RIGOH	Technical Bulletin		No. RTB-013	
SUBJECT: Ink Cartridge Seal				DATE: Nov.30 1990 PAGE: 1 of 1
PREPARED BY: S.Asai CHECKED BY:		FROM: Copier	Technic	cal Support Section
CLASSIFICATION: Action Required Troubleshooting Retrofit Information	Revision of some some some some some some some some		Ges 5	EL: 5/930/950 5210/5130/5170 140/1060/1070

RIGOH	Technical	Bulletin		No. RTB-014
SUBJECT: Drum Retrofit to prev	vent Ink Leakage	(Refer to M/B No	. 63)	DATE: Jan.31.1991 PAGE: 1 of 3
PREPARED BY: S.Asai CHECKED BY:		FROM: Copier	Γechni	cal Support Section
CLASSIFICATION: Action Required Troubleshooting Retrofit Information	Revision of s		Ges 5	EL: 5/930/950 5210/5130/5170 1140/1060/1070

Technical Bulletin		No. RTB-015	
SUBJECT: Thermal Head Clean	er Cap			DATE: Jan.31th '91 PAGE: 1 of 2
PREPARED BY: S.Asai CHECKED BY:		FROM: Copier	Technic	cal Support Section
CLASSIFICATION: Action Required Troubleshooting Retrofit Information	Revision of s Information of the control of the con		Ges 5	EL: 15/930/950 5210/5130/5170 1140/1060/1070

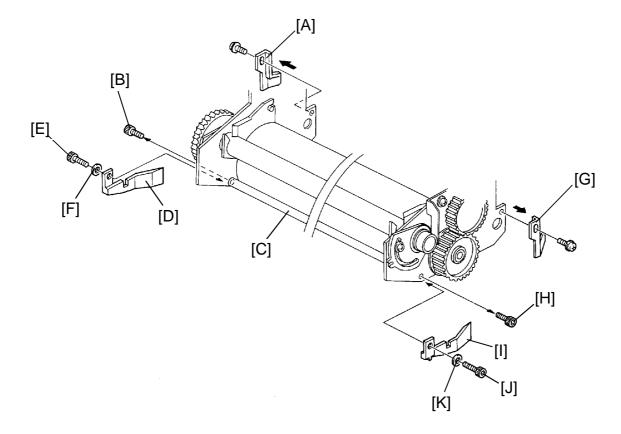
4. Remove the old front drum blade (C2004745) [A] (1 screw).
5. Remove the internal hexagon head screw (M4 x 6) [B] securing the ink roller shaft stay [C], then install the new front drum blade (C2074745) [D] and secure it with the internal hexagon head screw (M4 x 8) [E] and the flat washer [F].

6. Remove the old rear drum blade (C2004746) [G] (1 screw).

7. Remove the internal hexagon head screw (M4 x 6) [H] securing the ink roller shaft stay [C], then install the new rear drum blade (C2074746) [1] and secure it with the internal hexagon head screw (M4 x 8) [J] and the flat washer [K].

Note: Do not re-use the old front and rear drum blades.

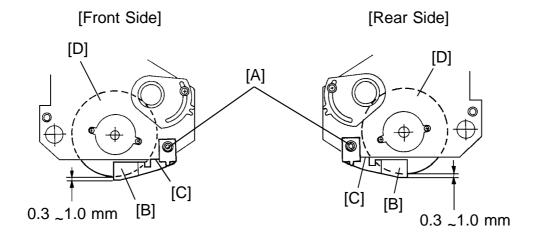
1. Tighten each (front and rear) internal hexagon head screw [A] so that the drum blade [B] contacts the lower edge [C] of the side plate.

Note 1: Make sure that the clearance between the ink roller [D] and the drum blade [B] is 0.3 to 1.0 mm.

Note 2: Make sure that the drum blade edge [E] contacts the ink roller [F].

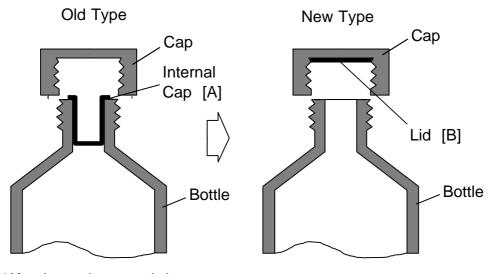
There has been a problem with the internal cap [A] getting stuck inside the thermal head cleaner bottle and it is difficult to pull it out.

The internal cap has been changed to a lid [B] as illustrated below:

This modification has been implemented since the November '90 production run. Please note that the part number of the thermal head cleaner remains the same.

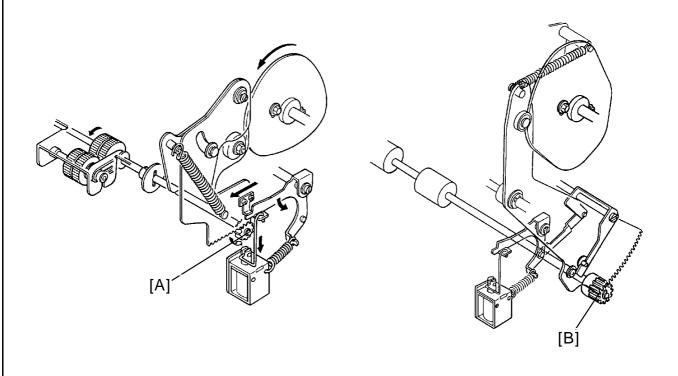
The one-way clutches inside the paper feed and second feed roller gears have worn the roller shafts smooth. The clutch slips and paper jams or is not fed. This tends to occur during high speed printing and is more likely to occur on machines that exceed the recommended monthly copy volume. When the feed mechanism is manually operated to check the paper feed, paper feeds correctly.

- 1. Remove the paper feed roller gear [A] and the second feed roller gear [B].
- 2. With fine sandpaper, lightly sand the roller shaft surface at the point where it comes into contact with the one-way clutch. This increases the coefficient of friction.
- 3. If paper jams continue to occur, replace the one- way clutch.
- 4. If paper jams continue to occur, replace the roller shaft together with the one-way clutch.
